Inspection Photos

2/19/2021

Operator: CHEVRON USA INC - 16700

Location ID: 314658

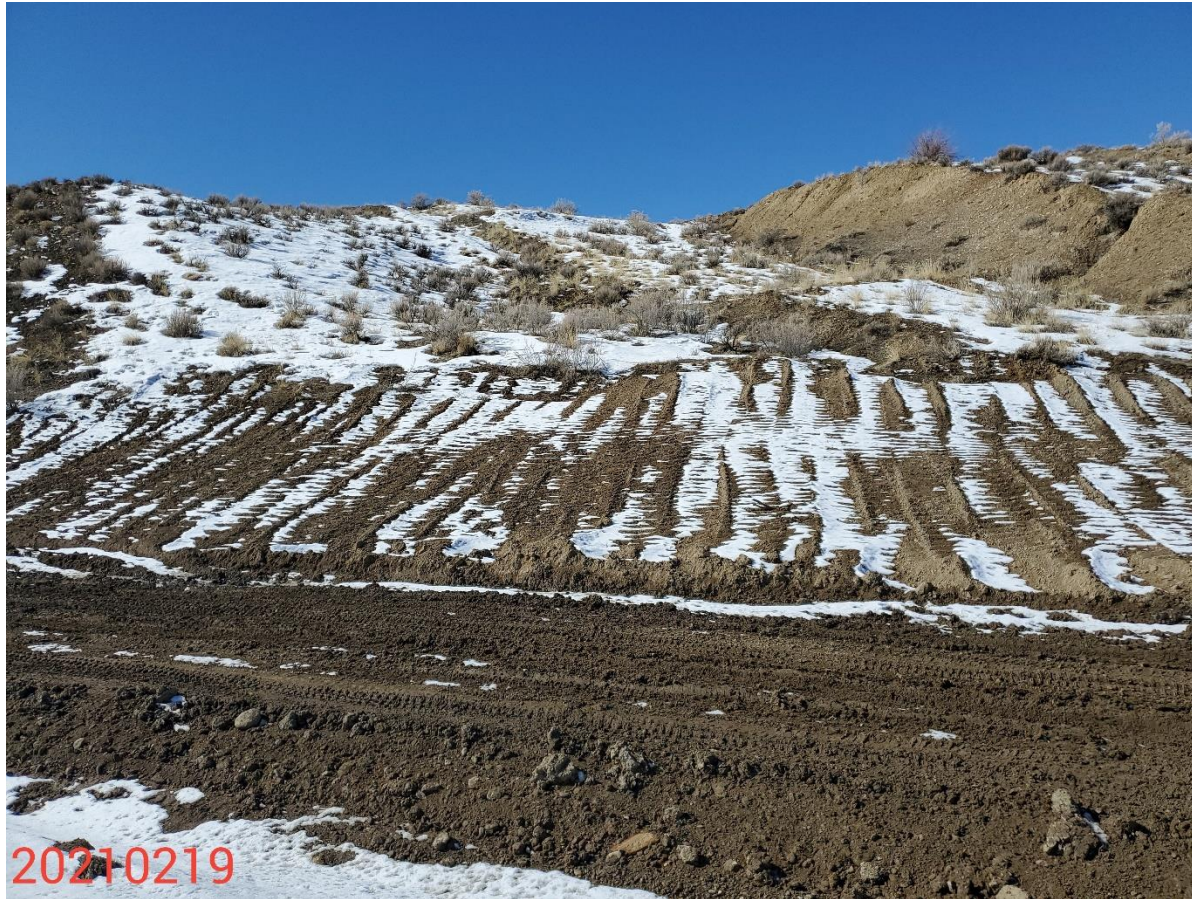
Photo 9: Photo taken from the west end of the Location, facing west. Photo shows operator has installed surface roughening (tracking) along the western slopes. Tracking has been installed in accordance with good engineering practices (parallel to the contours). However tracking is a temporary measure that should be used in conjunction with other erosion and sediment controls; no other erosion and sediment control measures observed on Location.
